Memorandum to the City of Markham Committee of Adjustment

January 8, 2021

File: A/092/20
Address: 19 Thorny Brae Drive – Markham, ON (Thornhill)
Applicant: Elina Eidkham
Agent: MDI Development Inc.
Hearing Date: January 20, 2021

1 PROPOSED NORTH ELEVATION
A-3 SCALE 3/16"=1'-0"

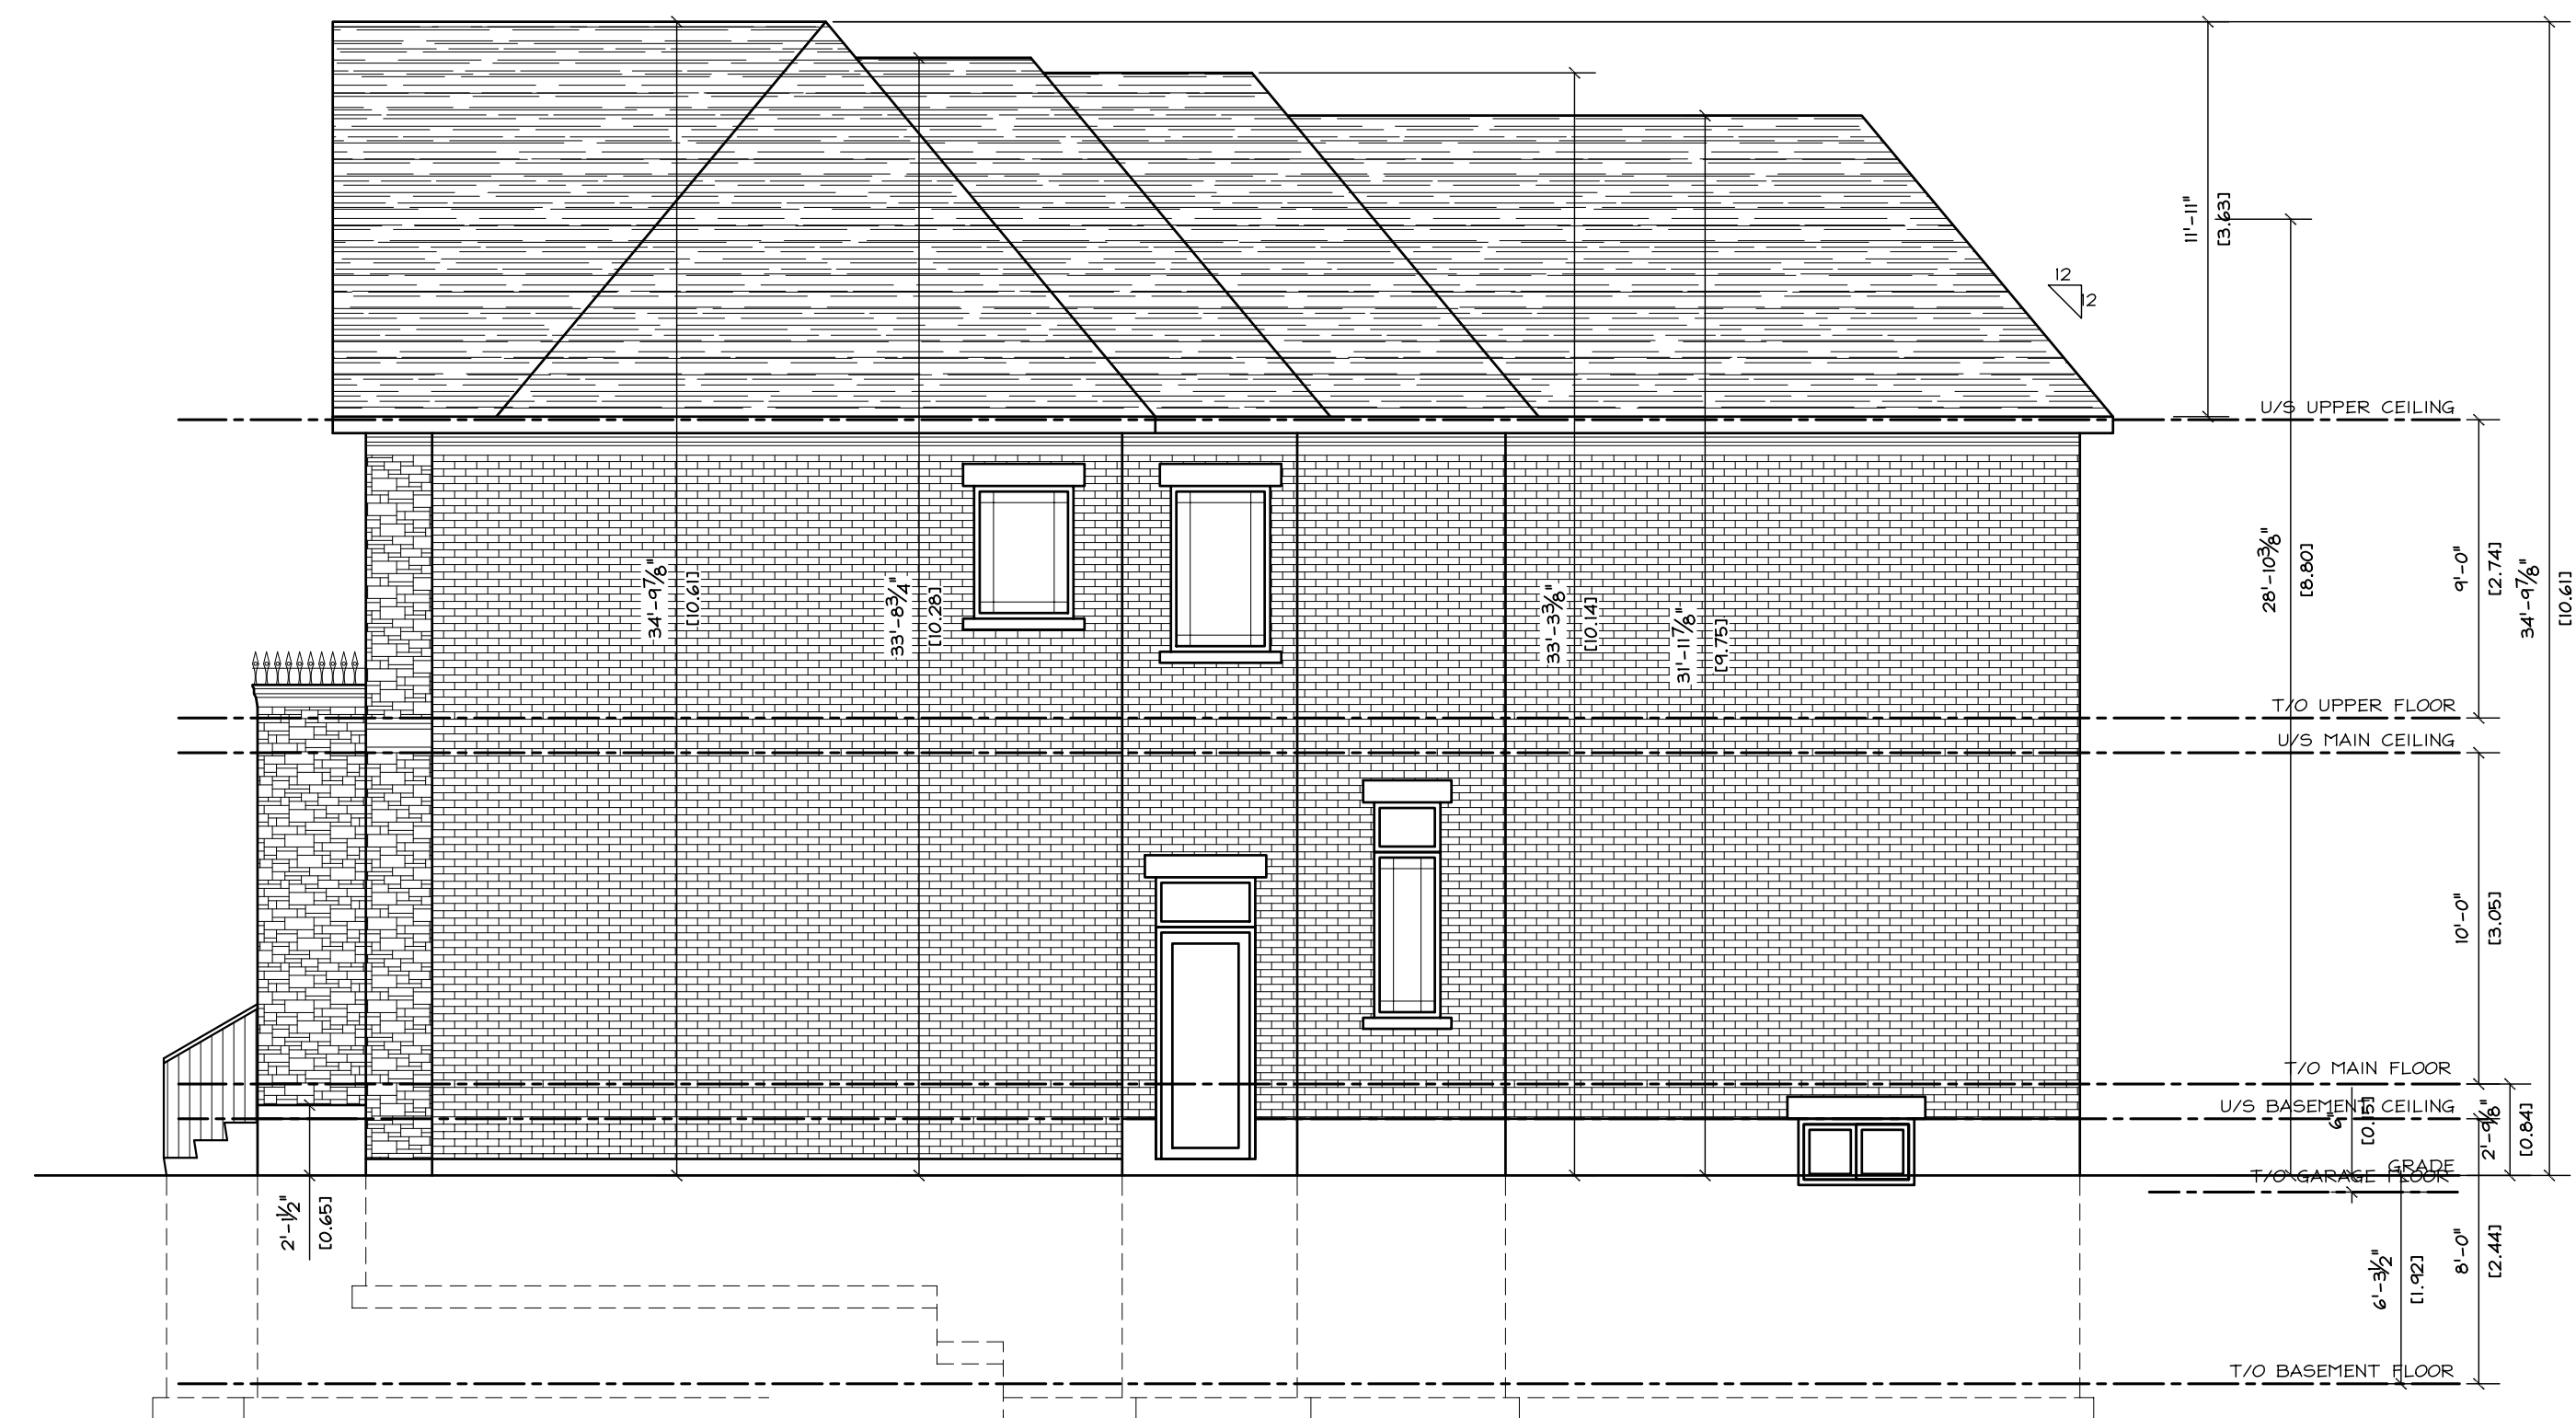
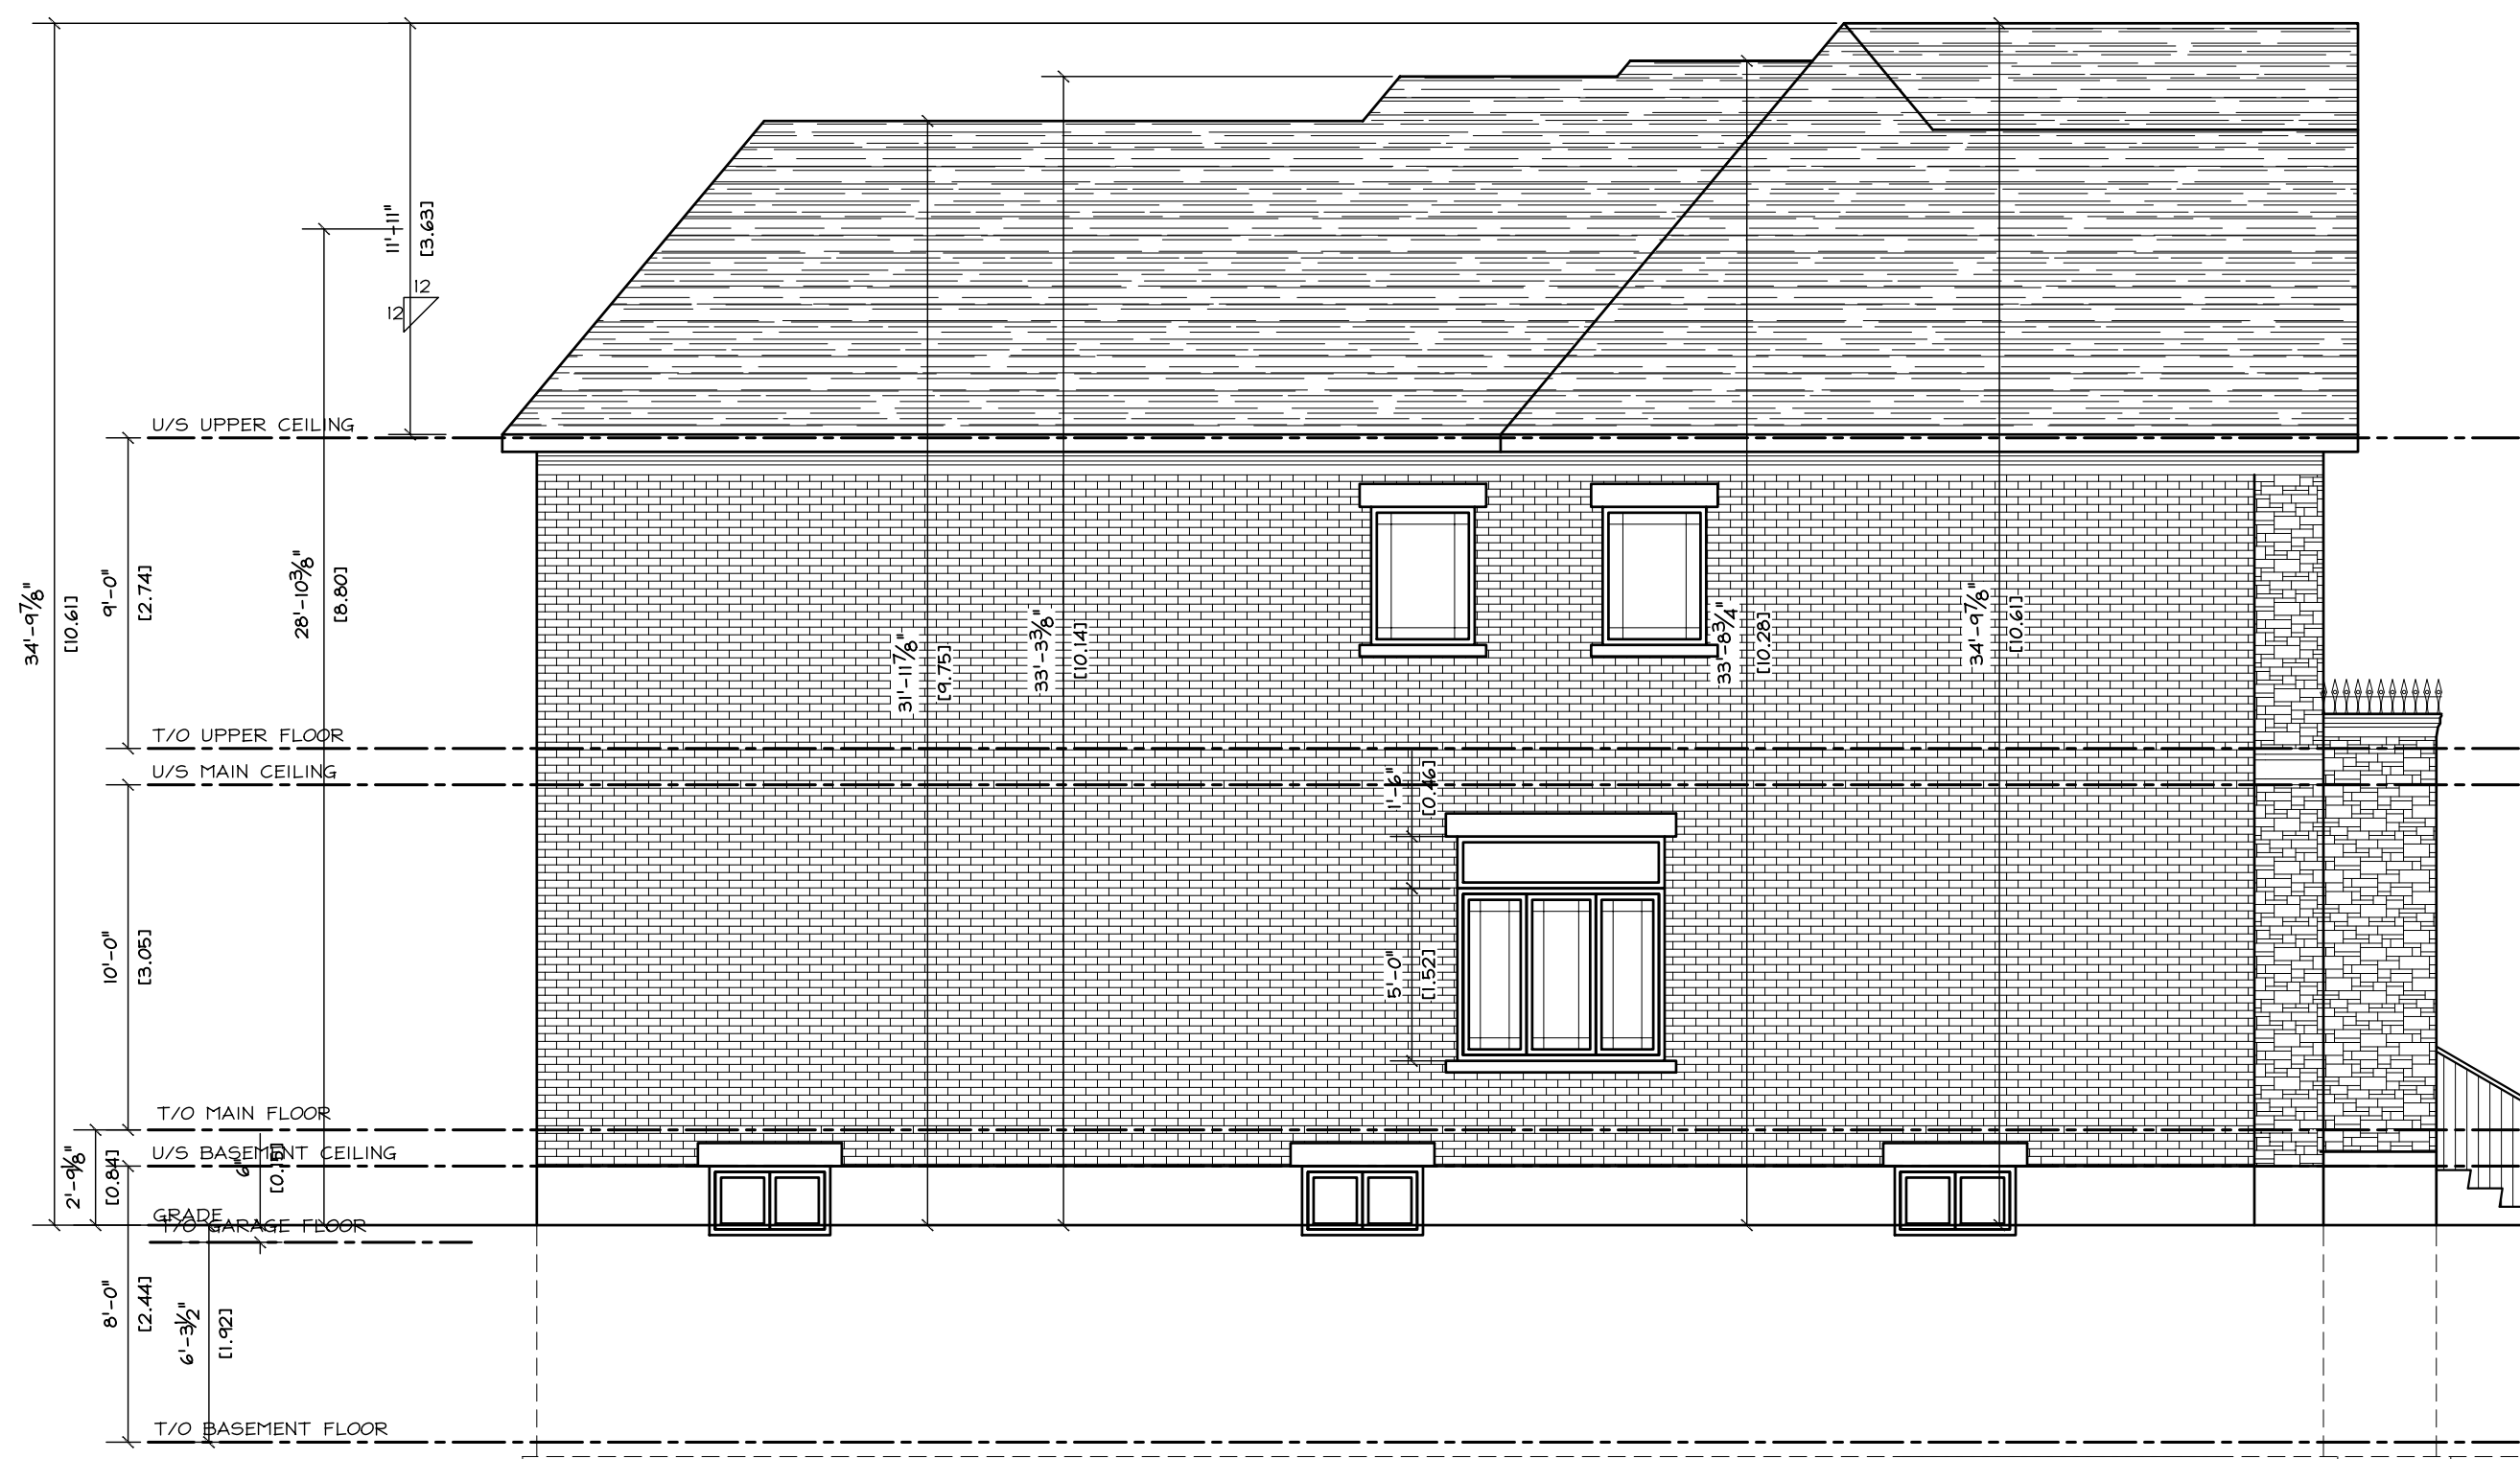
Increase in Maximum Building Height

The applicant is requesting a maximum building height of 28.87 ft (8.80 m), whereas the By-law permits a maximum building height of 25.0 ft (7.62 m). This is an increase of 3.87 ft (1.18 m).

The applicant initially proposed a height of 9.10 m (29.86 ft). New infill developments should have regard to the height and massing of established homes to ensure the overall character of the neighbourhood is maintained. In considering the scale of the existing built form within the surrounding area regulated by the By-law permissions in effect, staff had some concern with the initial variance request. The applicant has worked with staff to reduce the height of the proposed dwelling, and while the reduction is minimal, staff are of the opinion that the revised height is more to scale with other existing dwellings within the surrounding area built circa 1967.
